**Shenzhen Divoom Technology Co., LTD.****Declaration of Product Modifications**

This is to request a Class II permissive change for FCC ID: A8I-DIPOW-35 originally granted on 12/26/2024.

The changes to the motherboard are as follows:

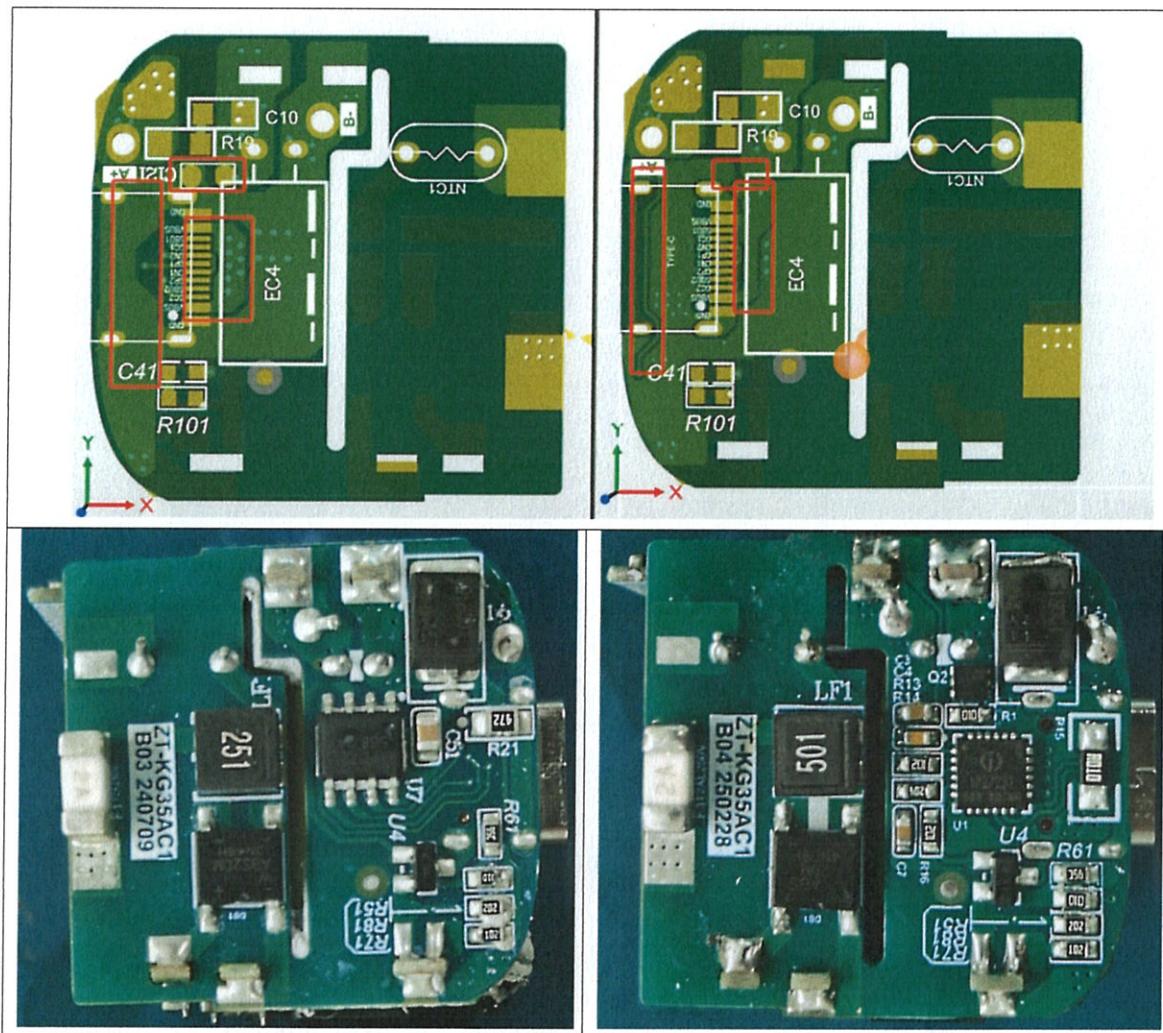
Replace the protocol chip from XPD719 to IP2723 to meet the power requirements of the display.

Replace XPD719 and its peripheral components C51 and R21 with IP2723 and its peripheral components C3, C4, C7, R1, R13, R14, R15, and R16.

The red box indicates the position to be changed.
